# SERVICE INFORMATION

## STANDARD AND TRIUMPH VEHICLES

<b>No.</b>	SPORTS/5/A	RECOMMENDED LUBRICANTS	<b>Date</b>	DECEMBER 1957
------------	------------	------------------------	-------------	---------------

<b>No.</b>	SPORTS/25/B	CONNECTING ROD BEARINGS	<b>Date</b>	SEPTEMBER 1957
------------	-------------	-------------------------	-------------	----------------

DESCRIPTION	MODEL
FITTING OF LISTING STICK	TR. III

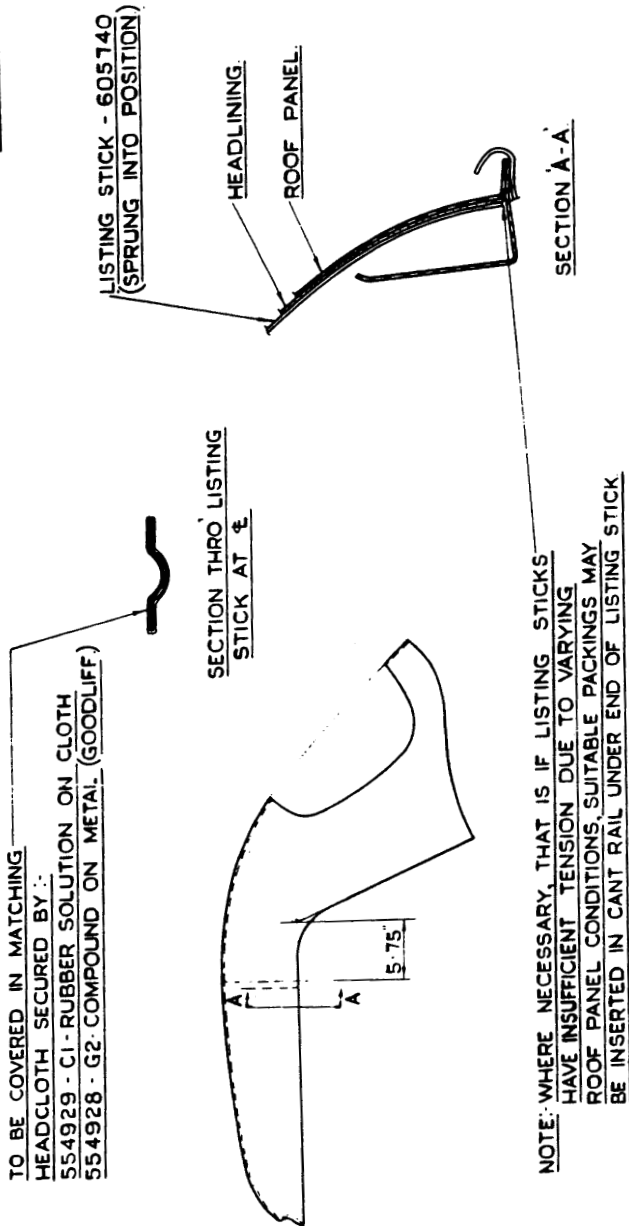
In order to prevent the headlining "festooning" when the adhesive fails after a period of service and to obviate the necessity for removing and refining the trim a service scheme for the introduction of a listing stick has been prepared.

The listing stick should be covered with the same material as the headlining and although fitted on the underside of the lining and visible is in no way unsightly.

The listing stick should be fitted as explained in the illustration and the necessary items can be obtained from our Spares Division as per the following details:

TO BE COVERED IN MATCHING HEADCLOTH SECURED BY :  
554929 - C1 - RUBBER SOLUTION ON CLOTH  
554928 - G2 - COMPOUND ON METAL (GOODLIFF)
